23 INDIVIDUALS

Palmdale - Burbank - RECORD #4026 DETAIL

Response to Submission 4026 (Allen Salkin, Journalist and Resident of Acton, September 2, 2022)

Figure 1 –Aerial photograph showing wildlife movement opportunities, looking north from Agua Dulce Canyon Road, through the Linkage Design, across the SR 14 freeway corridor with UC Davis Wildlife-Vehicle Conflict Hotspots identified.

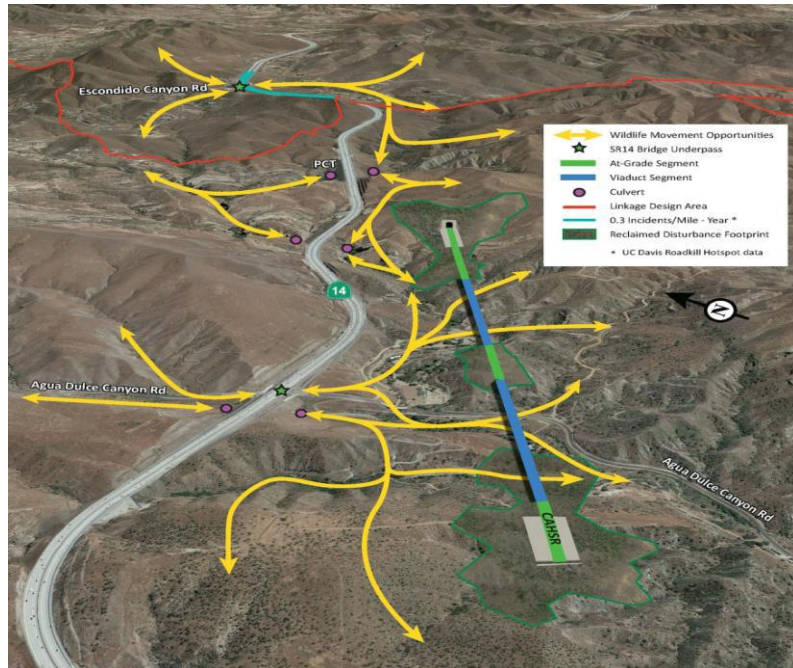
Wildlife connectivity is one of my main concerns. Either alternative needs to put sufficient crossings, making a system not a few token crossings. Studies showing the best sites, corridors that can be used and fencing for track avoidance and guiding must be designed.

Figure 3 –UC Davis' Real-time Deer Incidents &Wildlife-Vehicle Conflict (WVC) Hotspots map, September 16, 2023

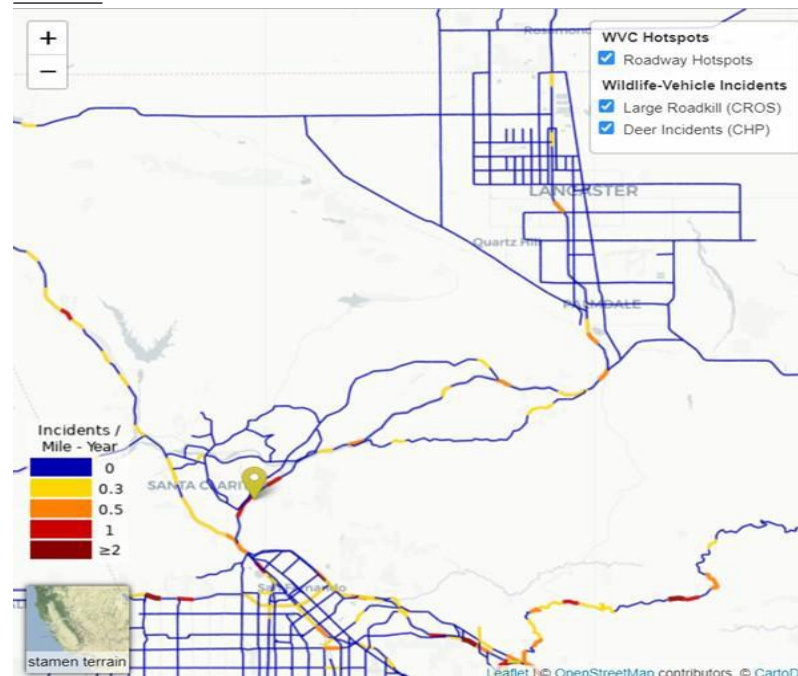
year (attached Figure 3). The hotspot map Areas identified as high wildlife use areas align with permeable sections of the SR14 and SR14A Alternatives also illustrated on attached Figures 1 and 2. Those areas that are not permeable were reviewed for crossing opportunities where wildlife could move across the existing landscape. Two additional crossings were added to address crossing interval spacing in an area that had a long at-grade segment to provide additional wildlife crossing opportunities near Una Lake (SR14A and E2A Build Alternatives) and adjacent to the California Aqueduct (SR14A, E1, E1A, E2, and E2A Build Alternatives) (see p. 3.7-197 of Draft EIR/EIS). The WCA determined the effect to wildlife movement was less than significant because of the extensive network of permeable tunnels and viaducts that align with the existing SR 14 freeway bridge undercrossings and wildlife roadkill hotspots, maintaining wildlife movement. Refer to Graphs 6-1 through 6-15 of the WCA that illustrate the relative comparison of existing and project permeability for each of the focal species.

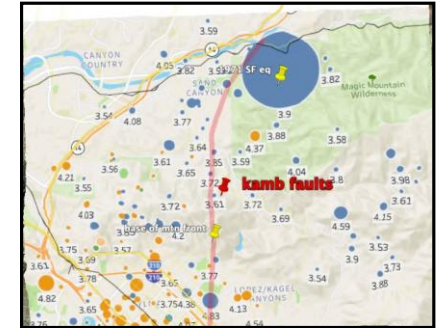
The DEIR's insistence on limiting fault rupture to features from specific State sources such as Alquist Priolo maps, which are intended for use on small local construction projects such as housing tracts and shopping centers, is a serious error and would mislead any bidding contractor attempting to address project safety. Fault ruptures are by nature dissimilar to geophysical seismic wave attenuation processes such as those that lie at the heart of most probabilistic earthquake models which have been developed since the late 1960s. These models, which may be seen as increasingly naïve for estimation of rupture potential, given recent experience with earthquakes, are suitable for distant earthquakes where the earthquake can be characterized by a simplified conceptual model, usually featuring a fault line containing an epicenter which is imagined to be the source of the vibratory disturbance. However, recent earthquakes have shown that local fault rupture is erratic and dependent on many variables and, as often as not, invisible and detached by many miles from earthquake epicenters. For example, the fault ground ruptures shown on this Alquist Priolo map (with one proposed tunnel alignment shown in green) are 9 miles away from the epicenter of the 1971 earthquake that is often taken to be the fault that produced them, which is located in the San Gabriel Mountains off the map to the north. The line does not avoid the indicated Veterans Fault which is known to extend below ground far both east and west from the indicated surface break.

From the time of the earliest investigations of the San Fernando earthquake as by Yerkes and Wentworth,²⁰ geologists have been warning that the San Fernando Valley is underlain by many faults, invisible at the ground surface, of greater or lesser magnitude, including faults with greater potential displacements than the 1971 earthquake. In fact, those authors cautioned that a reasonable design earthquake should be more than Magnitude 7 for this area. But even if the map showing here were a complete catalogue of all of the faults that would show movement at the tunnel depth, one would be left with the question of how so many potential and fatal track disturbances (more than an inch or two) could be reasonably mitigated.

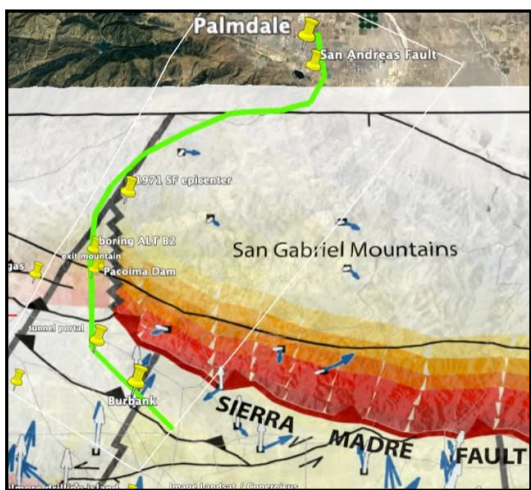
The geology section of the DEIR considers only three faults which it considers to be significant potential for track displacement: the San Andreas, San Gabriel, and various surface faults in the San Fernando Valley. However, the hydrology section of the DEIR report (Section 3.8) indicates there are other known and unknown faults on the alignment that could affect groundwater flow. Our view is that these unknown faults, to be discovered in a more extensive geotechnical investigation order during construction, will also need to be considered in regard to the question of track alignment and derailling.

However, it is likely that not all faults in the ANF have been mapped because of limited surface evidence and the inherent limitations of surface geologic investigations. Additional geological investigation would occur before final design and construction.

As stated by the commenter and shown in the Table 3.9-4 in Section 3.9 of the Draft EIR/EIS, all six Build Alternatives will cross the San Andreas Fault (Mojave Section) at grade near Lake Palmdale. Trackway profiles, stations, and ancillary features associated with all six Build Alternatives could experience violent seismic ground shaking, particularly near the San Andreas Fault (see Figure 3.9-19 in Section 3.9 of the Draft EIR/EIS). The anticipated design ground displacements would not "instantly and completely destroy the rail," although for the Maximum Considered Earthquake (MCE) event, extensive repairs or complete replacement of some components of the system may be required before train operation may resume. As established by GEO-IAMF#7, potentially hazardous faults crossed by the HSR Build Alternatives would be evaluated by conducting field investigations to establish updated estimates of levels of ground motion prior to construction and during final design. Final design would be further
